PENNSYLVANIA ELECTRIC COMPANY
THREE MILE ISLAND NUCLEAR STATION UNIT 1

Operating License No. DPR-50
Docket No. 50-289
Technical Specification Change Request No. 17

Technical Specification Change Request NO. 17

UNIT 1
ROD POSITION LIMITS
Figure 3.5-2A

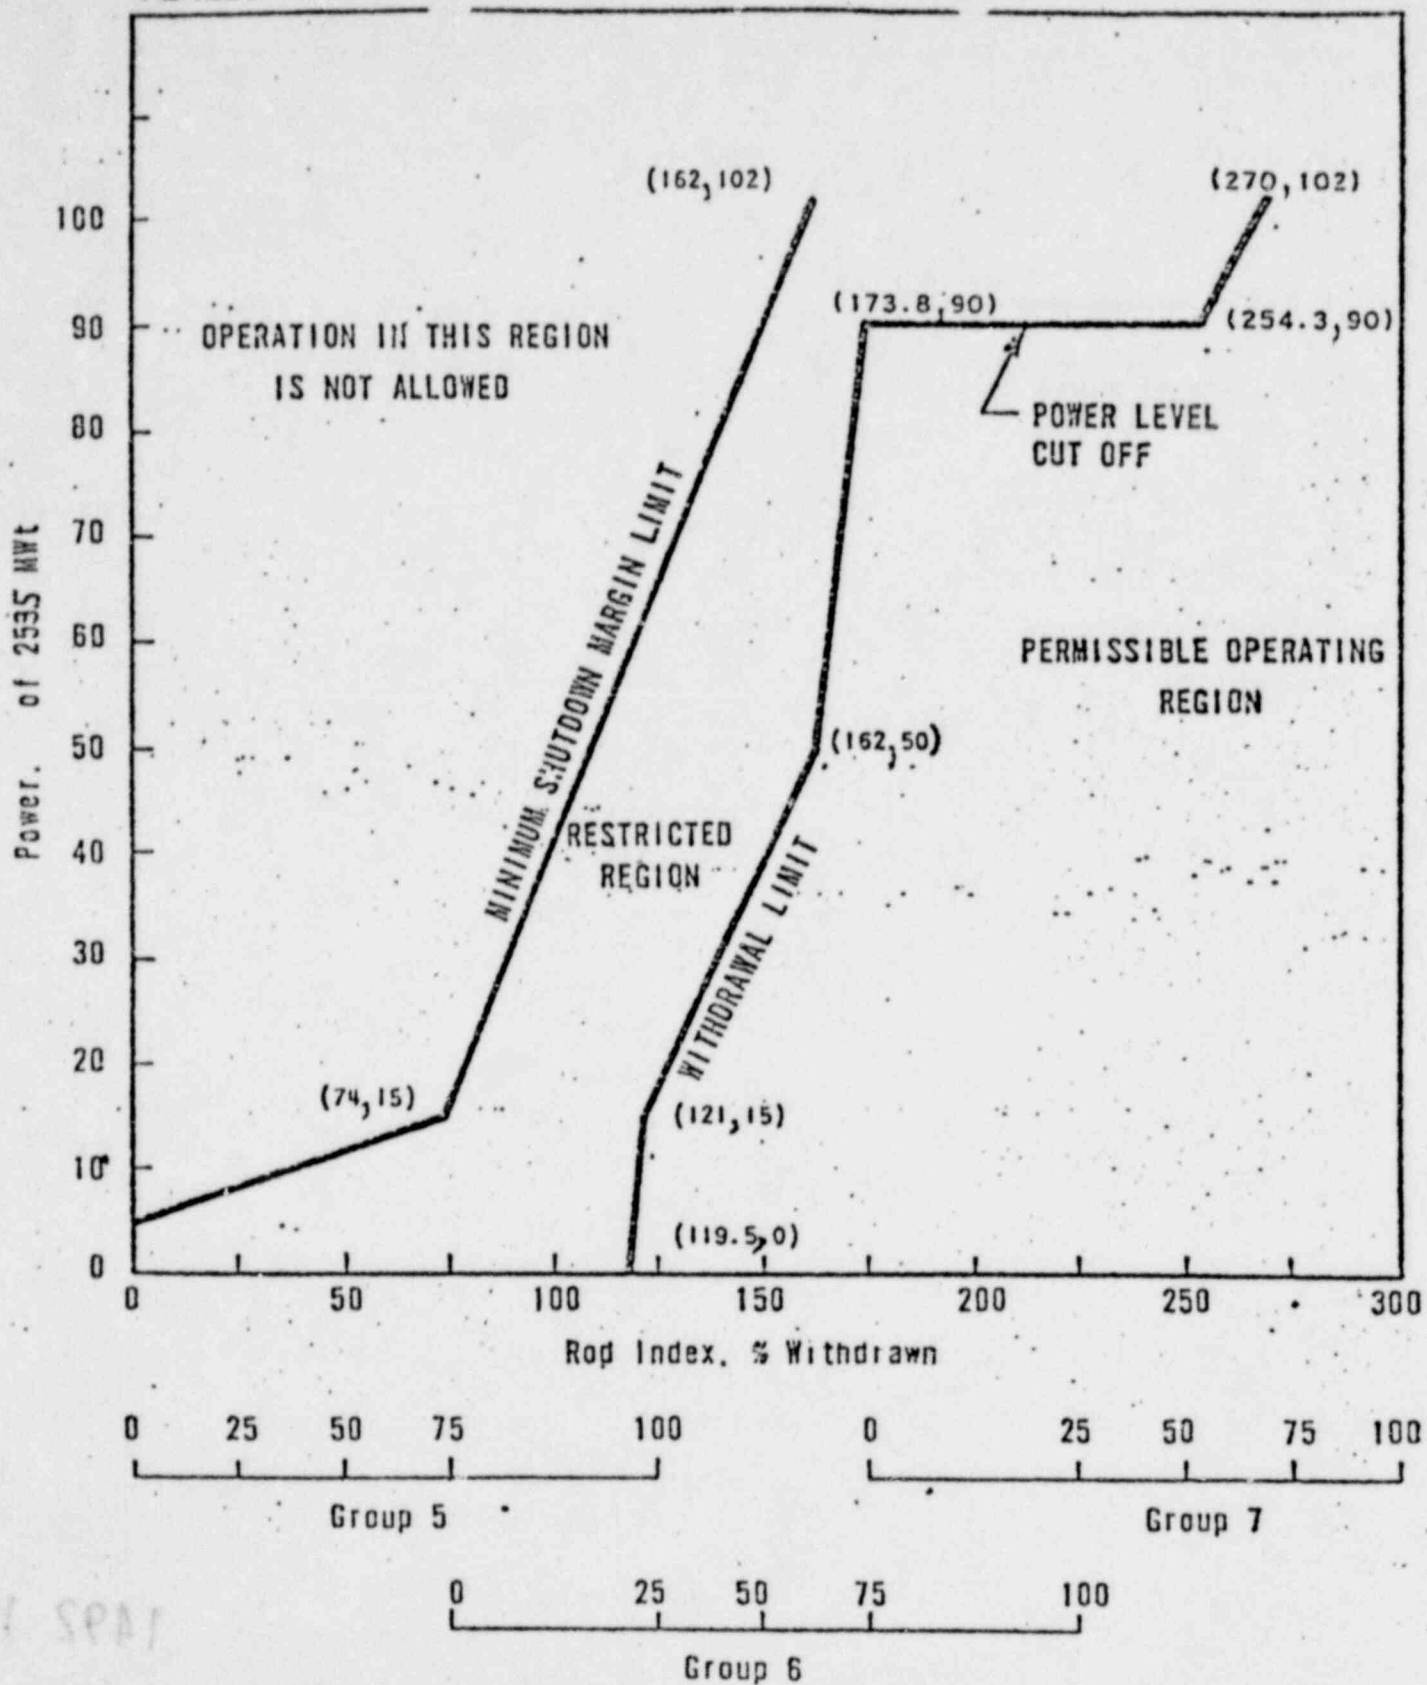
ROD POSITION LIMITS FOR 4 PUMP OPERATION APPLICABLE DURING
THE PERIOD FROM 253 ± 10 EFPD TO $440 \pm$ EFPD.

Rod index is the percentage sum of the withdrawal of Groups 5, 6 and 7

UNIT 1
ROD POSITION LIMITS
Figure 3.5-28

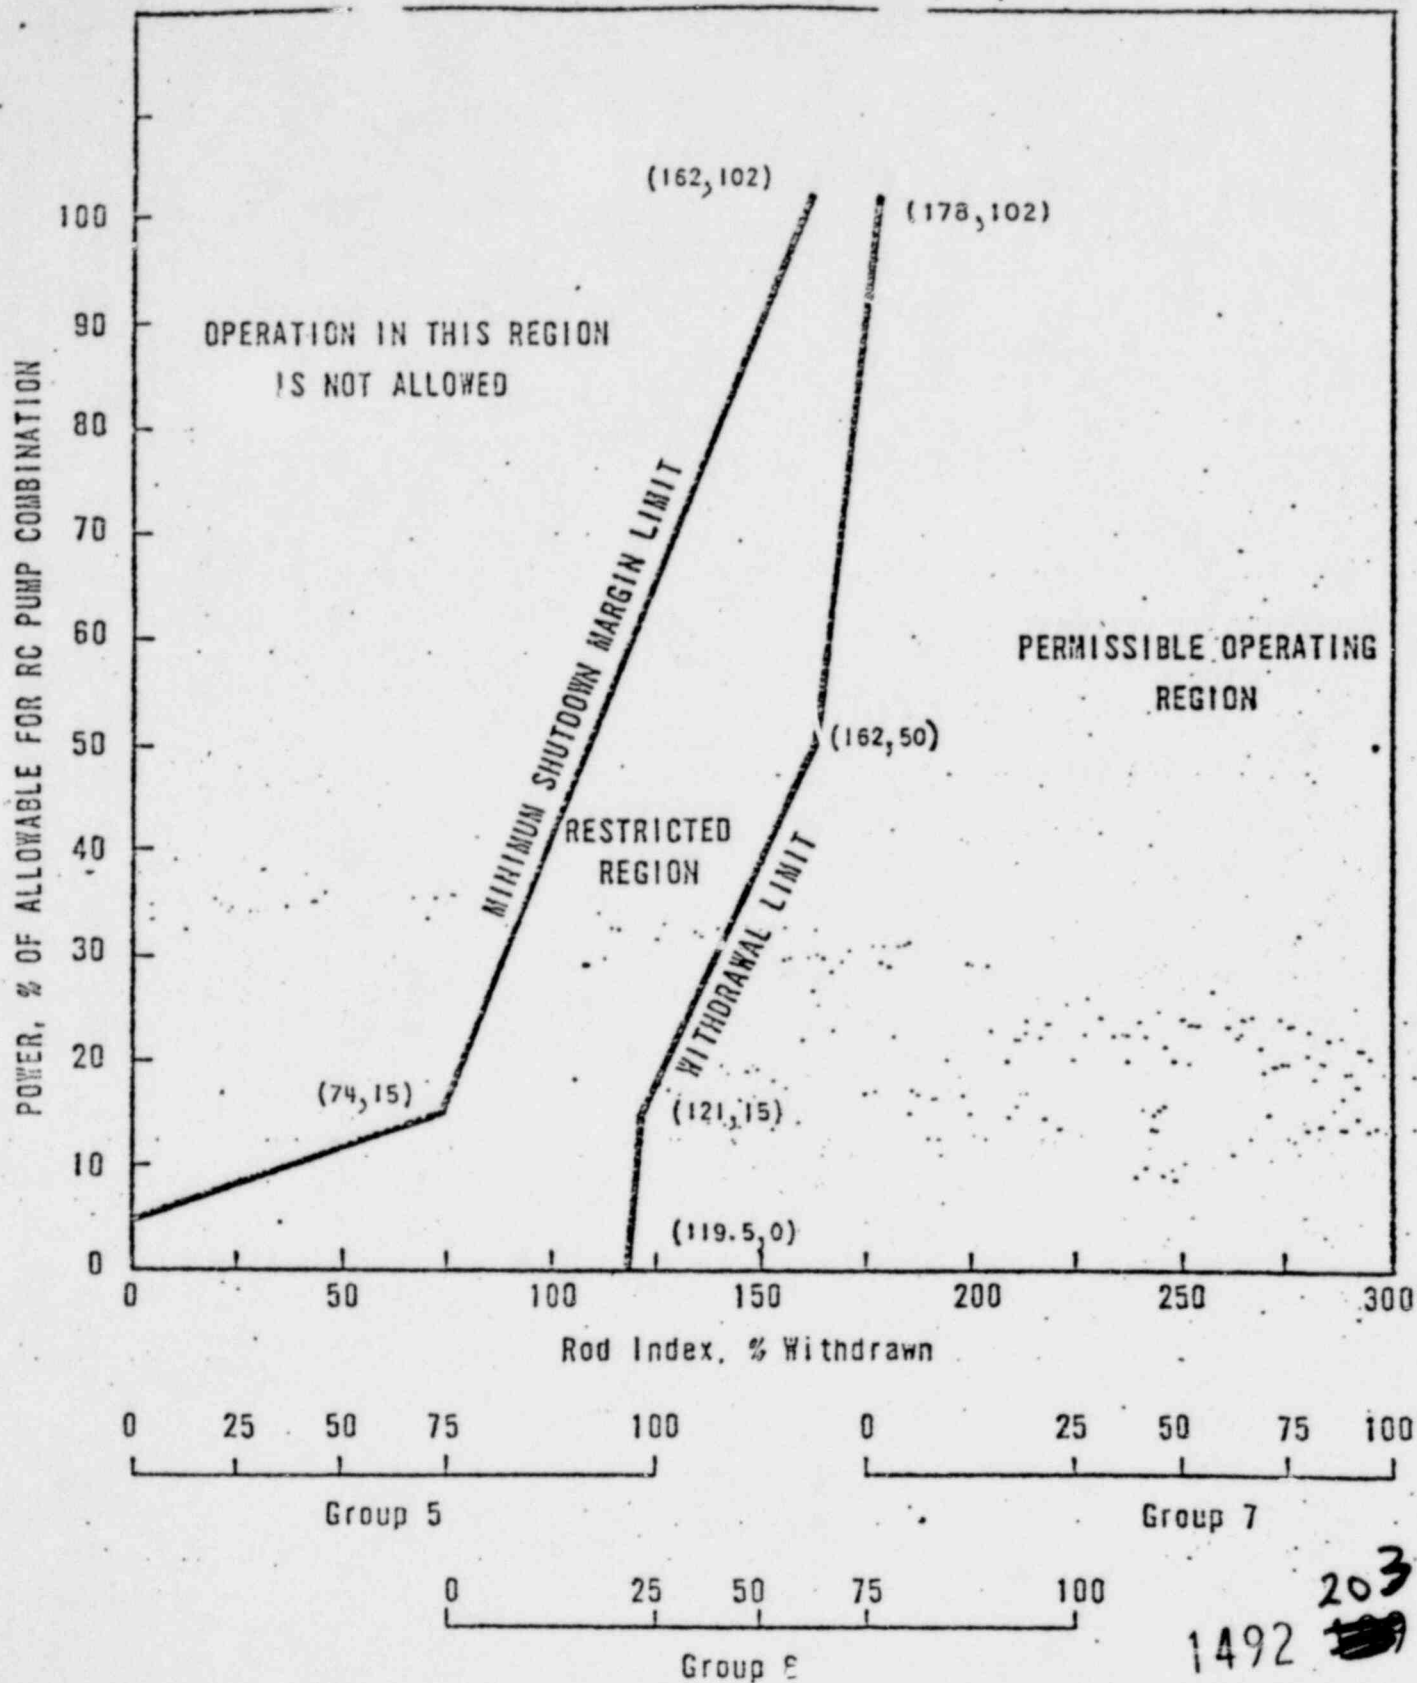
ROD POSITION LIMITS FOR 4 PUMP OPERATION APPLICABLE DURING THE PERIOD AFTER 4th ± 10 EFPD.

Rod index is the percentage sum of the withdrawal of Groups 5, 6 and 7.

UNIT 1
ROD POSITION LIMITS
Figure 3.5-2C

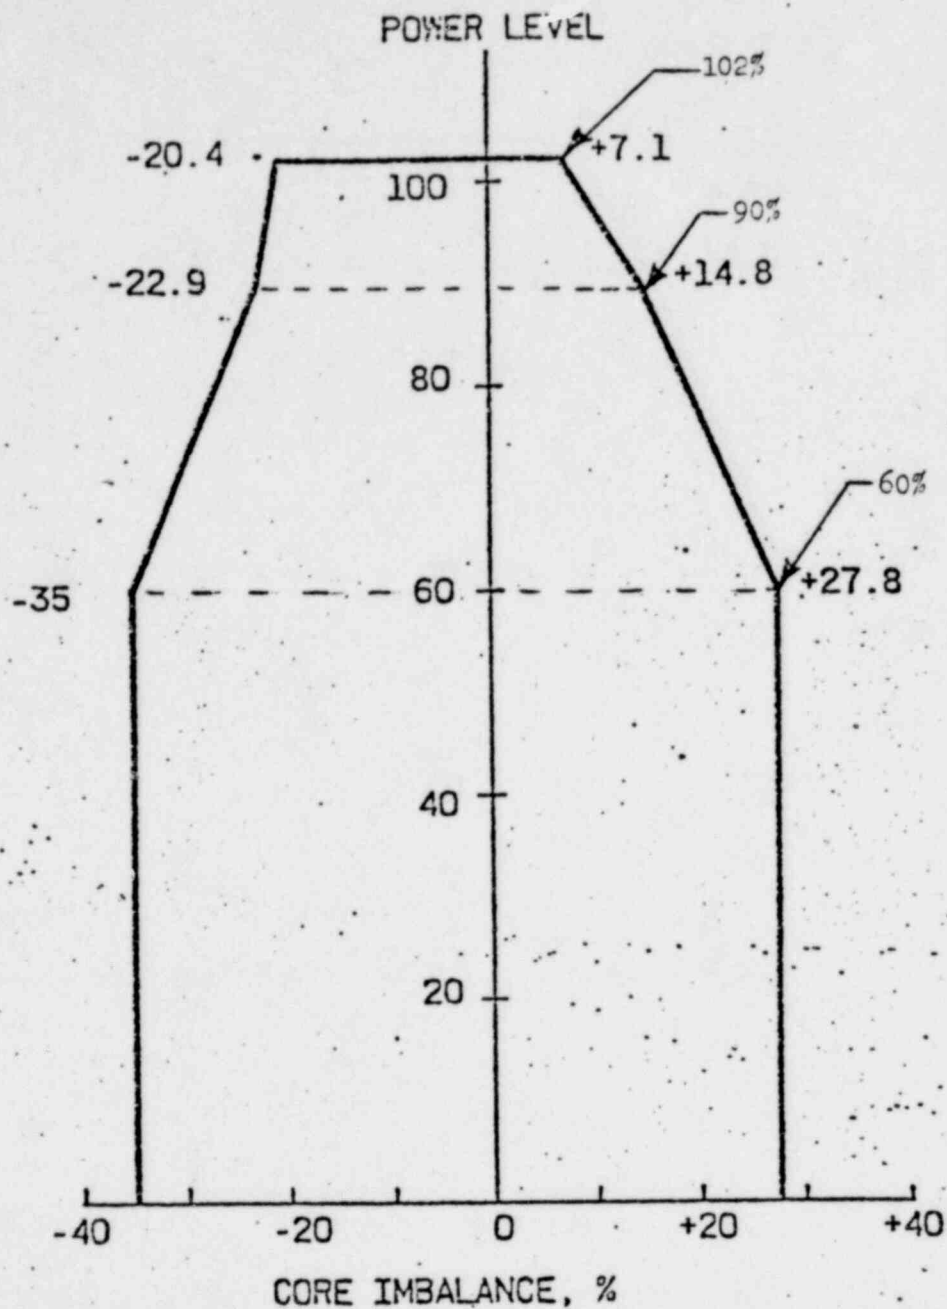
Rod index is the percentage sum of the withdrawal of Groups 5, 6 and 7.

Figure 3.5-2D

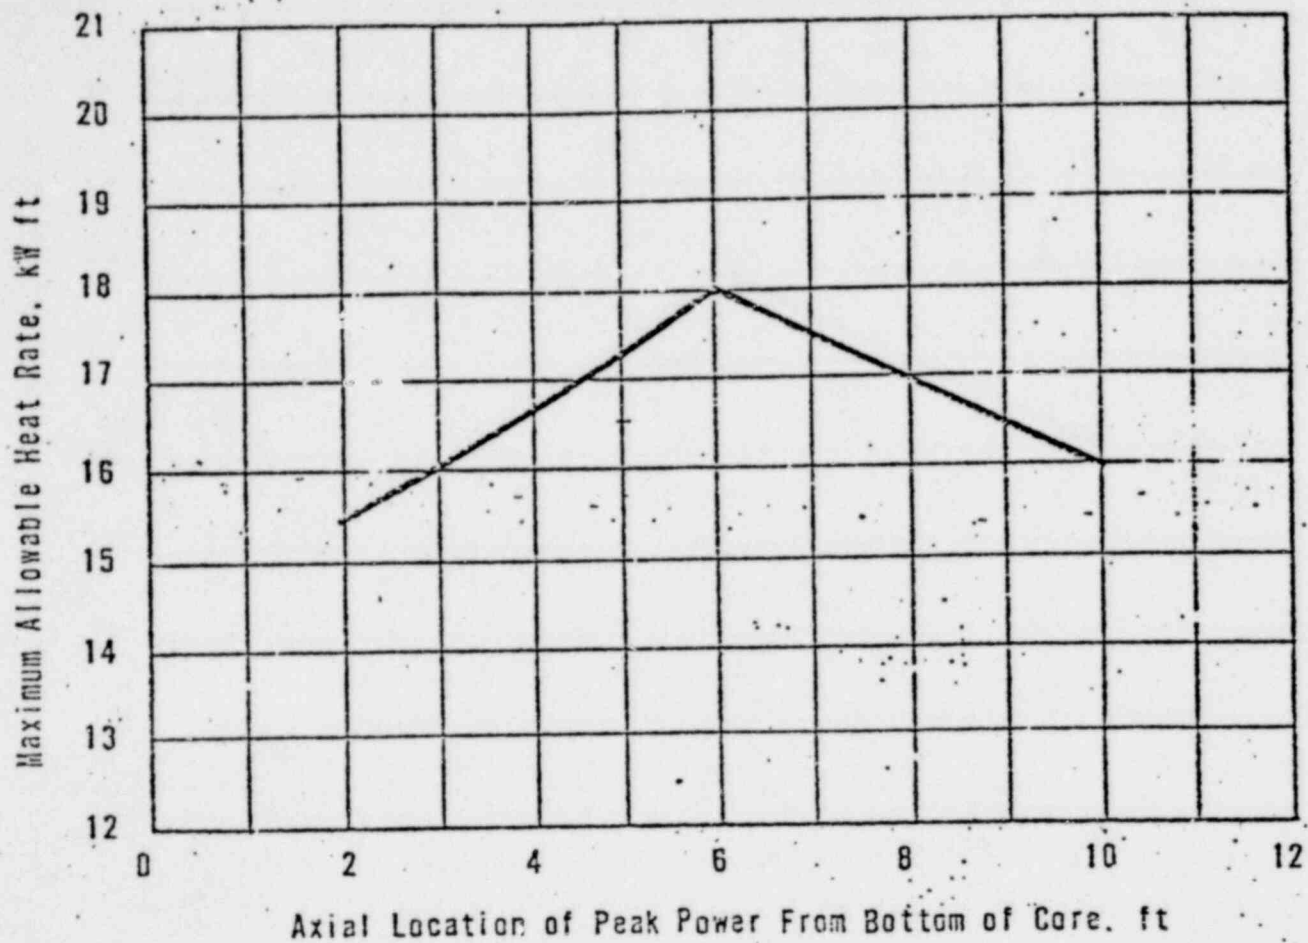
The power-imbalance envelope defined in Figure 3.5-2D is based on LOCA analyses which have defined the maximum linear heat rate (see Figure 3.5-2E) such that the maximum clad temperature will not exceed the Final Acceptance Criteria (2200F). Operation outside of the power imbalance envelope alone does not constitute a situation that would cause the Final Acceptance Criteria to be exceeded should a LOCA occur. The power imbalance envelope represents the boundary of operation
